Tillbridge Solar Project
EN010142

Volume 6
Environmental Statement Addendum
Document Reference: EN010142/APP/6.6

September 2024
Revision Number: 00

FIGURE NUMBER
Figure 3

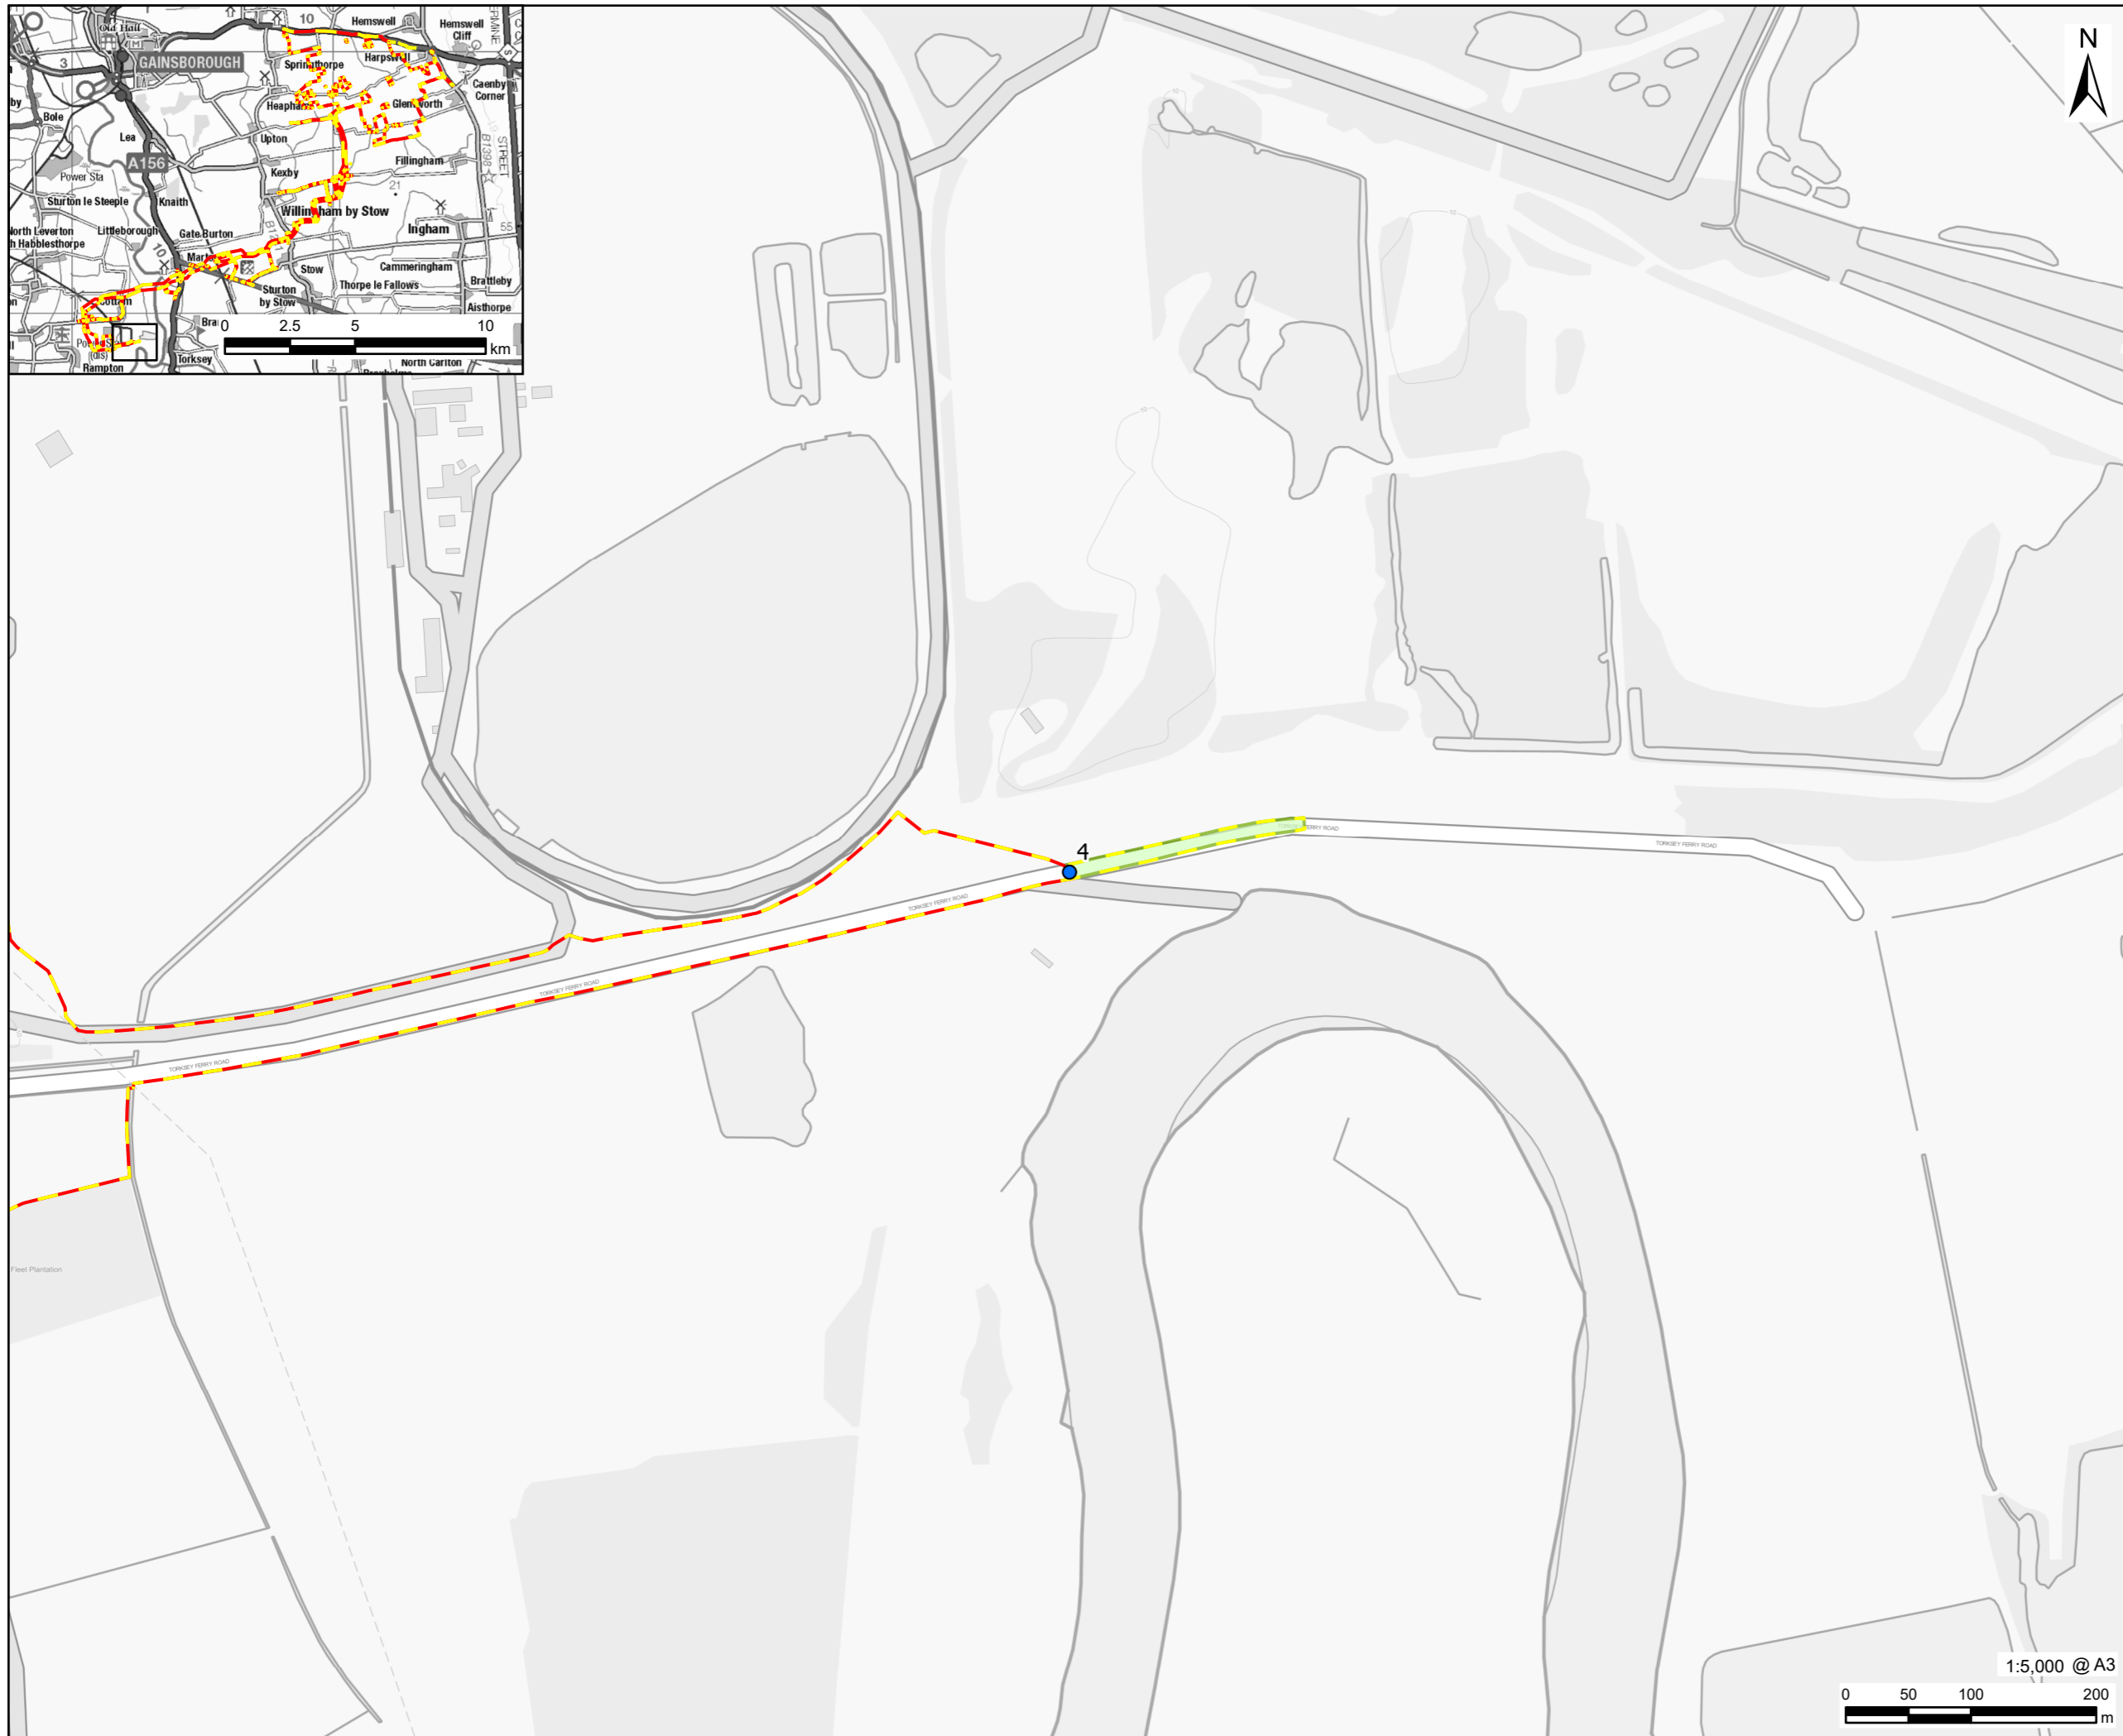
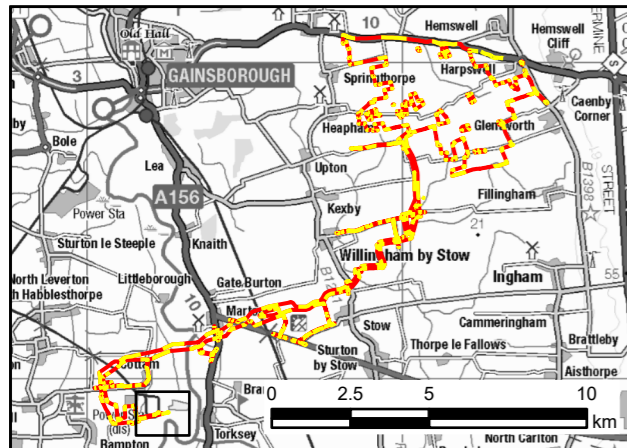
- 2.1.7 Through further refinement of the Scheme layout and design, the Applicant has determined that a triangular area of land previously thought required for the siting of a construction compound to the north of Willingham Road is no longer needed, with sufficient space for a compound being available on adjacent land to the west. As such, there is no longer a need for this land to be part of the Scheme. Plots 12-04a and 13-03a as shown on the **Land and Crown Land Plans [APP-006]** have been removed as part of this change (see **Figure 3: Change 3** and the revised **Land and Crown Land Plans [EN010142/APP/2.2(Rev01)]**).
- 2.1.8 This change will result in alterations to the Order limits and a reduction in the area of land included within the Order limits.

FIGURE NUMBER
Figure 4

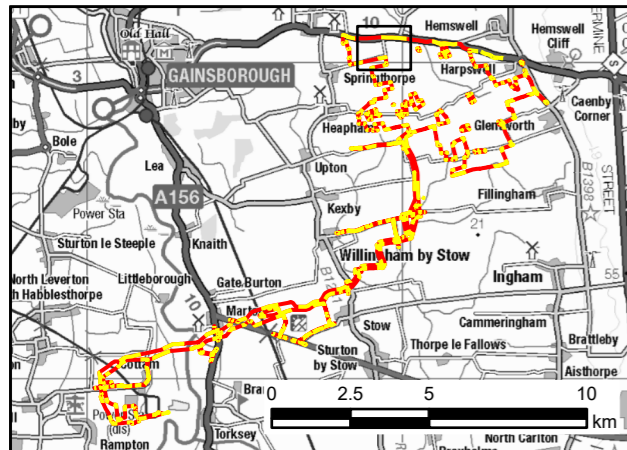
- 2.1.9 It is proposed that the Order limits are reduced along Torksey Ferry Road to remove land that, upon further refinement of Scheme layout and design, is no longer required in relation to the alteration of the layout of streets (see **Figure 4: Change 4**). This land is no longer necessary to facilitate access from Torksey Ferry Road into the National Grid Cottam Substation.

- 2.1.10 Plot 24-02 as shown on the **Land and Crown Land Plans [EN010142/APP/2.2(Rev01)]** has been reduced and modified as a result of the change.
